Value Planning Study

Final Report

California Department of Water Resources Through Delta Facility *Sacramento, California*

June 2007

Alternative No.: CF-04

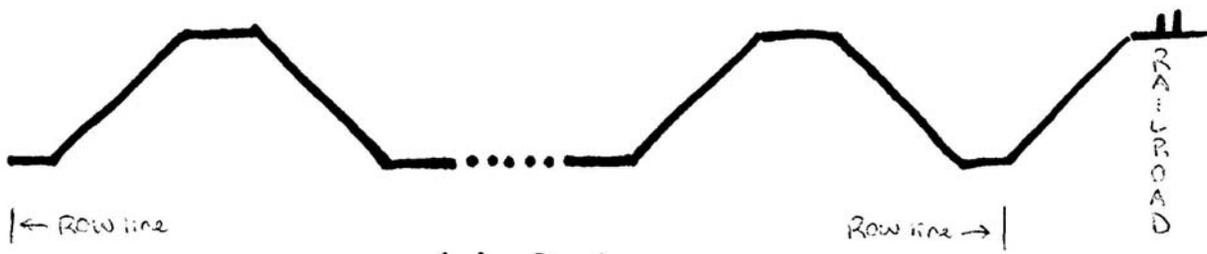
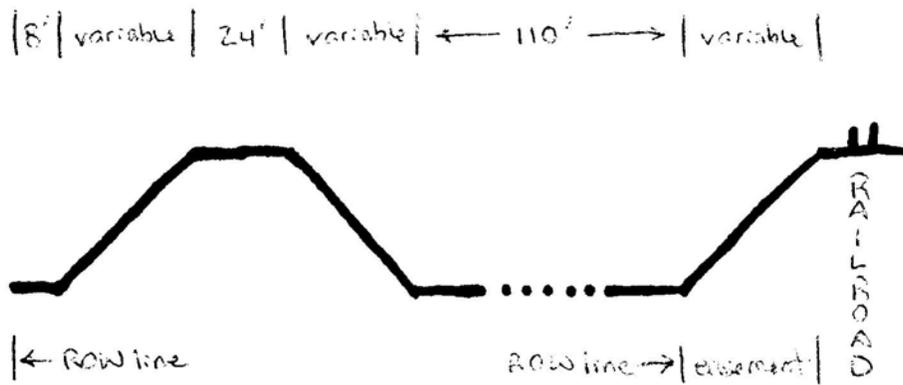
Divert 4,000 cfs of water from the Sacramento River at Hood and release it at the South Fork of the Mokelumne River at Beaver Slough. Use trapezoidal channel as show in TDF memorandum.

- Reduced water quality benefit – need to verify amount (similarity assumed)
- Delivers flows to area with hydrologic constraints (how constrained?)
- Uses Peripheral Canal alignment for a “different” project
- Will cause backwater at DCC and reduce its capacity to divert Sacramento River flows (may not be significant)

Alternative No.: CF-10

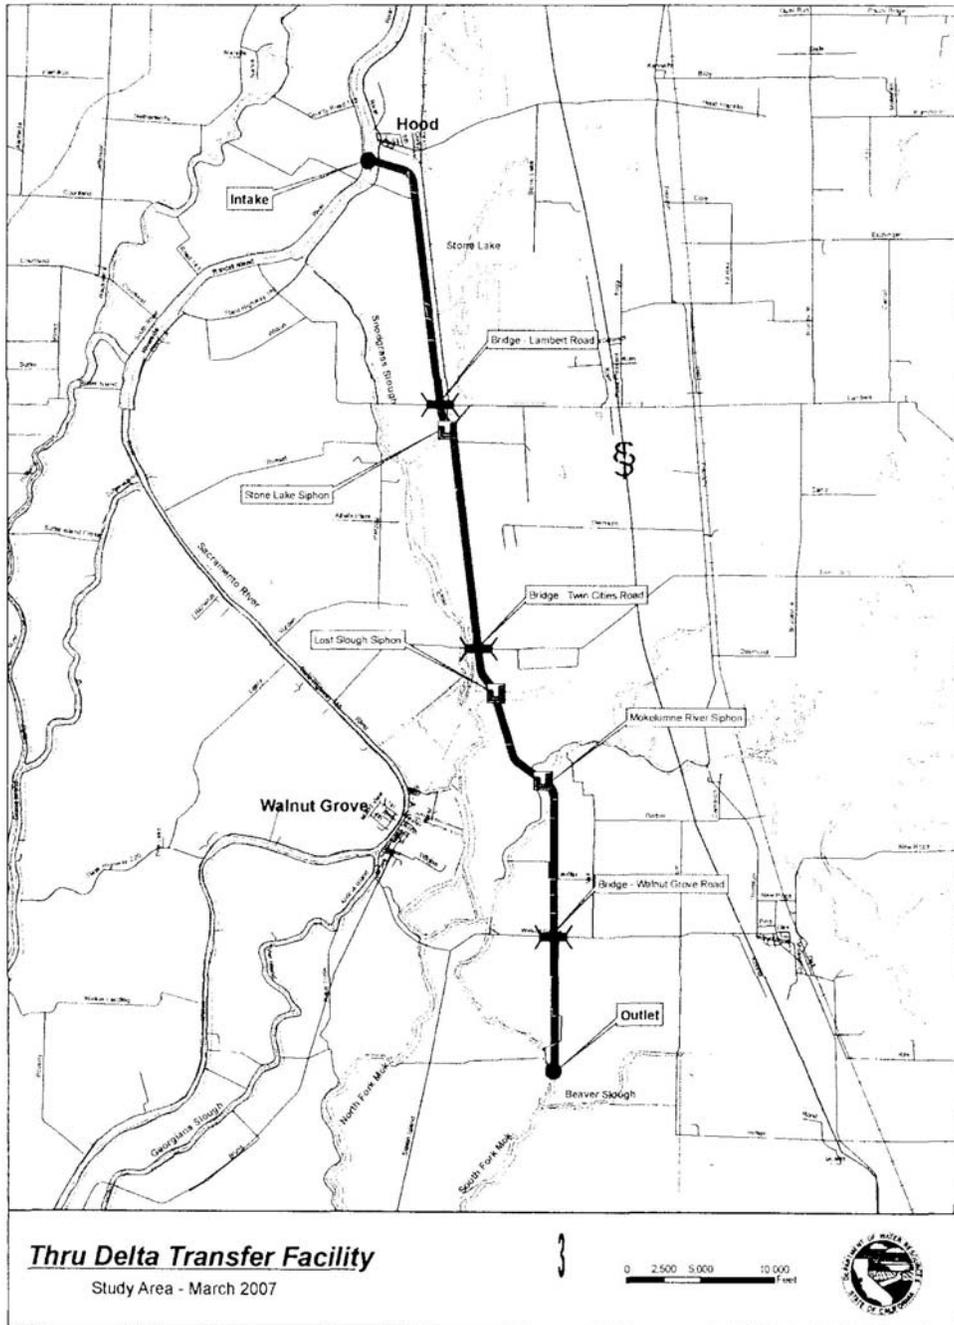
For this alternative, either an in-channel fish screen (multiple vee's) or an on-river fixed plate fish screen could be installed. For the purposes of evaluation of this concept, we assumed an on-river fixed plate screen. The fish screen facility would include an approximately 1,200 foot long by 20-foot-deep screen, which would provide a screen approach velocity of 0.2 fps. The screen would be designed to meet design criteria recommended for the TDF presented on page 19 of the Through Delta Transfer Facility Pre-feasibility Study with the exception that the screen facility would not meet the 60-second exposure for fish on the fish screen.

Refer to Figure 2 for a plan view of the fish screen facility and Figure 3 for a cross section of the proposed facility.

A pumping plant would be required for discharge to the Mokelumne River (Alternative A) or a discharge to the South Fork of the Mokelumne River (Alternative C). The pump station would include a trash rack and five pumping units, with a capacity of 833 cfs each, totaling a maximum pumping capacity of 4,165 cfs. The pumps would be axial flow pumps with the heads varying depending on the alternative selected.

Alternative B, approximately 4,000 feet long, would discharge to Snodgrass Slough upstream of the Delta Cross Canal (DCC). This alternative is the same as Alternative A except that the crossing of Snodgrass Slough is eliminated and a canal would be required from the intake to Snodgrass Slough, eliminating the need for a pumping station.

Should the Department desire to extend the conveyance system to the South Fork of the Mokelumne River, a siphon under the Mokelumne River and an additional 2.5 miles of canal (extension of Alternative A) would be required south Mokelumne River. This alternative, approximately 4.5 miles long, is referred to as Alternative C.

Alternative No.: CF-15

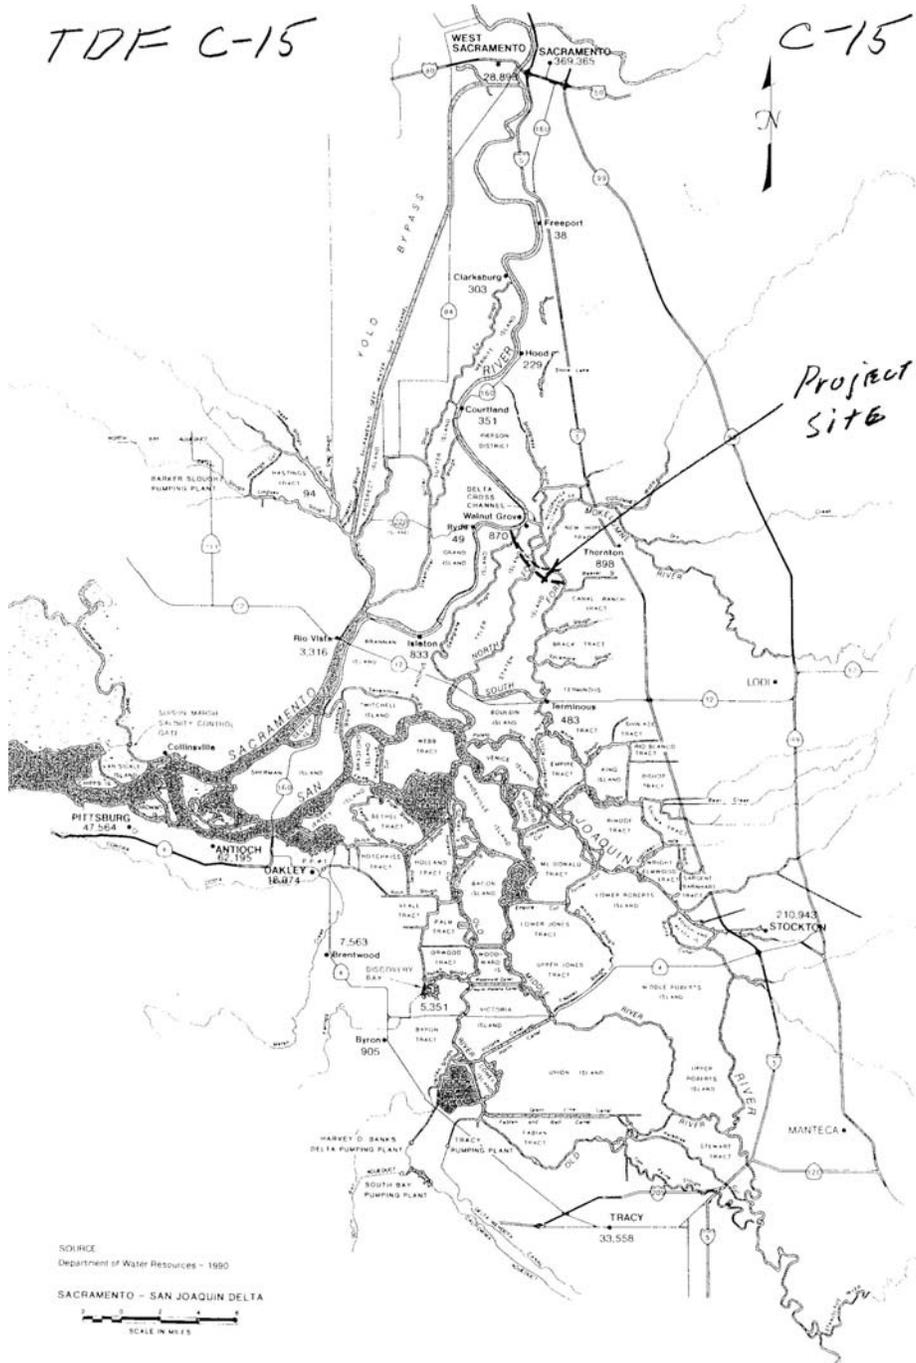
The major change in this Alternative to the Original Concept is the on-river fish screen with floating trash barrier, which results in no trash rack being required. It was determined that fish barriers at the outlet structure were preferred over fish ladders at the intake structure. A vertical bar rack with one-inch clear openings and a discharge velocity of 1.0 fps meets these criteria.

Alternative No.: CF-19

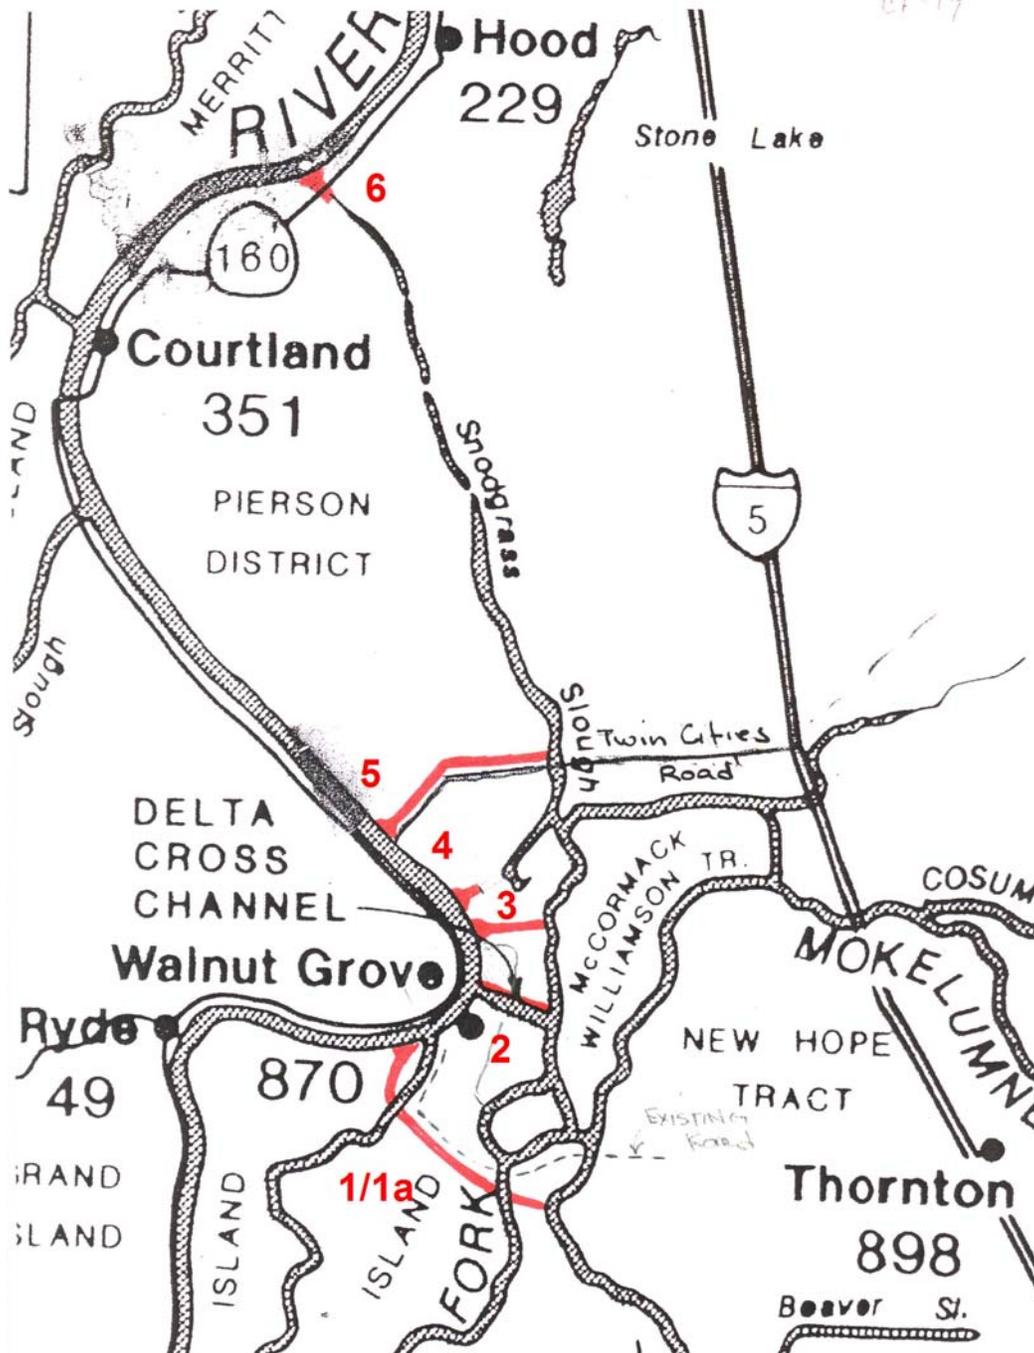
Table 2: Estimated Cost for Potential Diversion Sites

Site No.	Diversion To	Diversion Location	Estimated Cost (1000's)
1	Georgiana S., NF Moke., SF Moke	D/S Georgiana S.	\$60,653
1a	Georgiana S., NF Moke.	D/S Georgiana S.	\$49,450
2	Snodgrass S.	At DCC	\$57,633
3	Snodgrass S.	No. edge Locke	\$57,105
4	Snodgrass S.	At Meadows S.	\$54,513
5	Snodgrass S.	At Twin Cities Rd.	\$52,490
6	Snodgrass S.	No. end Snodgrass S.	\$55,655

Alternative No.: CF-38

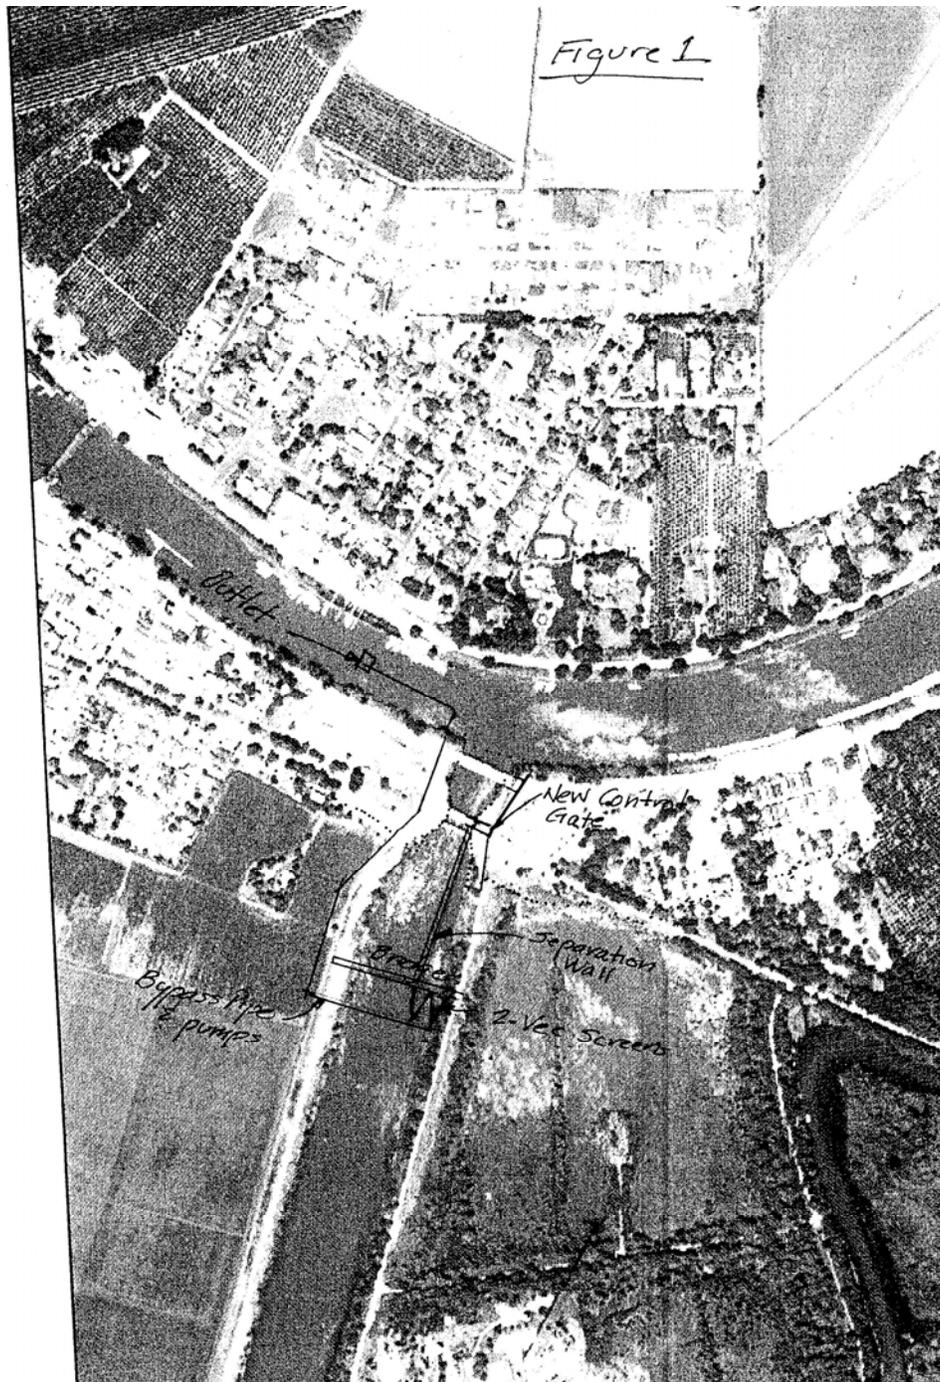
- Refurbishment of the existing DCC gates will add reliability of diversions toward the Delta export facilities
- Increasing the diversion capacity of the DCC will add flexibility to the facility operation by allowing one, two, or three diversion gates to be open for control of salinity at the export facilities
- The alternative improvements do not impact boat traffic in the area and, therefore, do not require mitigation
- Potential to stage screening of the entire DCC and realizing significant fish benefits and greater flexibility in operating DCC during periods when it would be closed due to fish concerns
- Keeps a higher flow rate in the Sacramento River for a longer distance

There may be a reasonable likelihood that the costs associated with refurbishment and enlargement of the DCC can be shared with the USBR and other beneficiaries of the project. The USBR recognizes that the existing facilities are nearing the end of their useful life and that refurbishment will be necessary, whether or not a Frank's Track Project is constructed.

On the attached sketches, we have shown 4,000 cfs being screen downstream of the headgates. In the future, the Department and the USBR may elect to expand the fish screens to the full width of the DCC. We assumed the ultimate capacity to be 12,000 cfs. A cost estimate was prepared for the 12,000 cfs fish screening option, as shown on the attached table. This total cost is about \$369 million. If only 4,000 cfs is screened, the cost for this alternative would be about \$157.5 million.

Alternative No.: DF-01

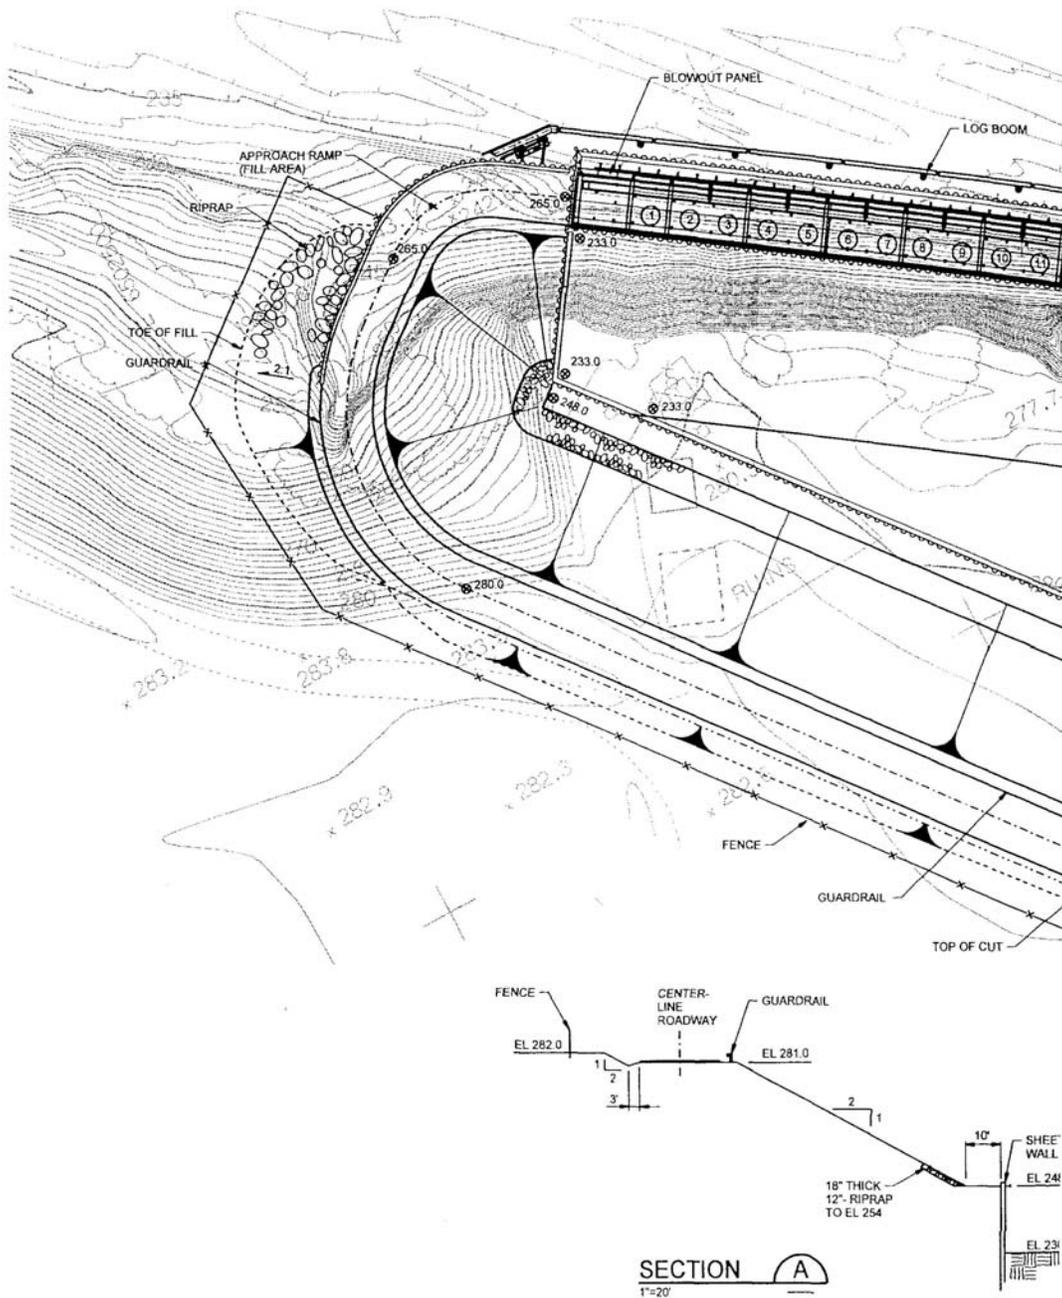
The proposed on-river fish screen facility would include approximately 1,200-foot long by 20-foot deep screens to provide an approach velocity of 0.2 fps. The fish screen facility would include 67 bays, each 15 feet wide and 20 feet deep. Blowout panel(s) would be provided as an emergency hydraulic relief system in the event of high differential head between the river and the forebay. The length of the screen depends on the characteristics of the river (i.e., depth, channel geometry, etc.) and final design flow.

The proposed fish screen facility would be constructed within a sheet pile cofferdam and would be founded on H-piles. Typically, the sheet piles are cut at the river bottom when the structure is completed. The screen facility would include the same screen material as described for the original concept. Behind the screen would be tuning baffles to assist in regulating the flows through the screen. At the base of the screen facility would be a sediment removal system. The purpose of this sediment removal system is to suspend sediment by water jetting so the sediment can be moved downstream through the screen facility to the forebay where it is easier to remove. An access road would be located the full length of the screen to assist in operation and maintenance. A log boom would be located in front of the screen facility to deflect debris back to the river. Solid panels would be located above the screens to eliminate debris from entering the forebay.

The costs will vary depending on the site. Experience has shown that the flat plate screens on the river are approximately double the cost of the vee screens in the channel for the same quantity of flow.

Alternative No.: DF-27

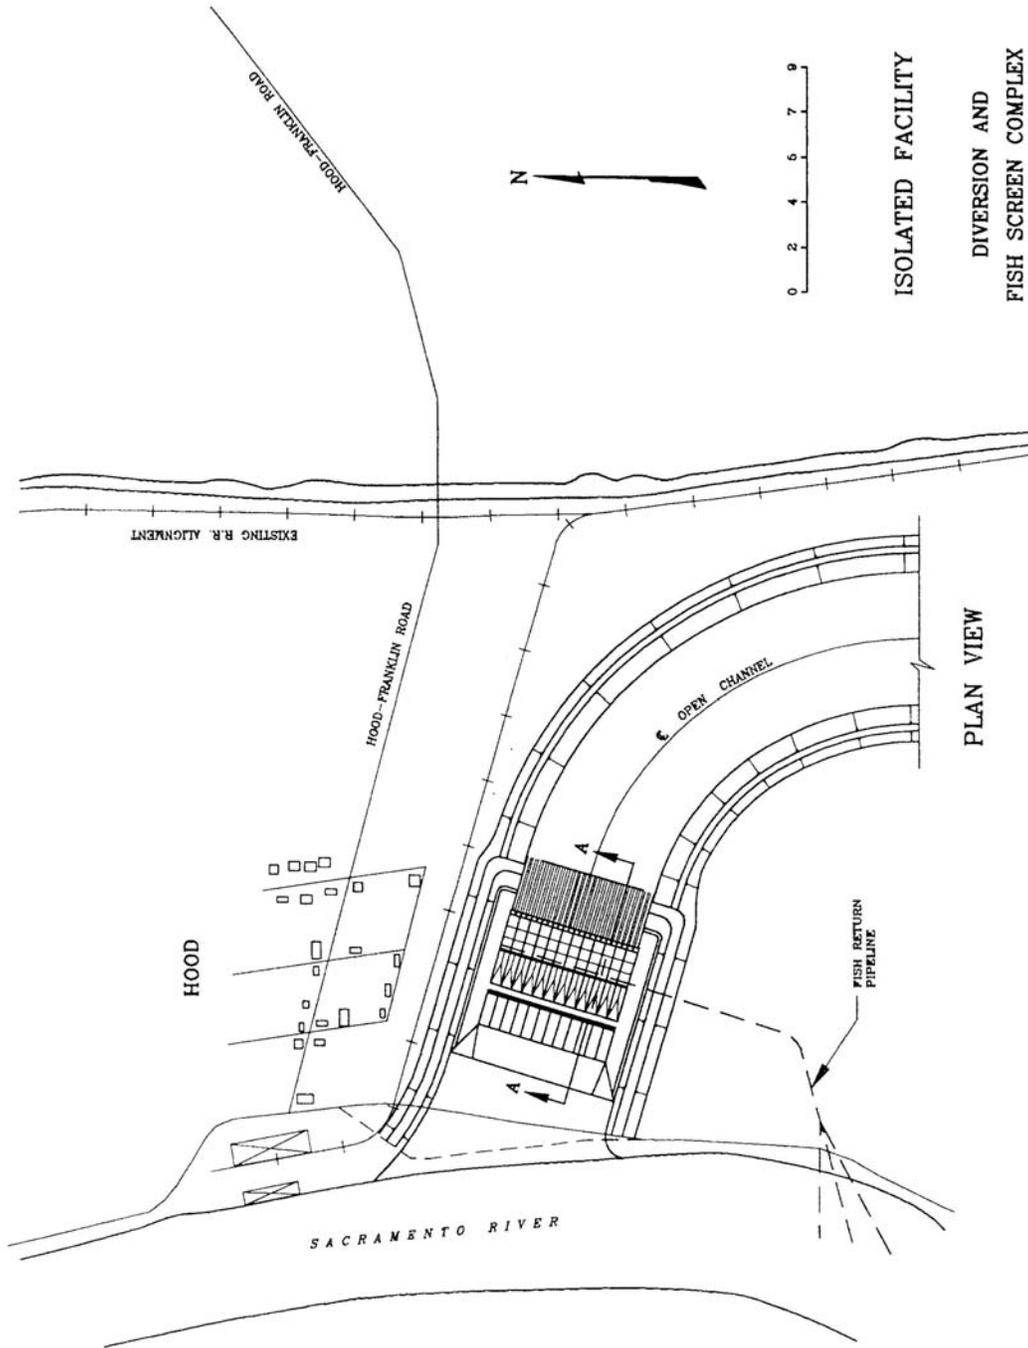
Provide trashracks and head gates on the river side of the levee and locate the intake structure on the land side

This approach also allows the canal fish screens and pump station to be isolated from the river for maintenance. Extra stop logs and lifting mechanisms would not be required.

It also can allow for a low deck level for the trashrack structure for seasonal use.
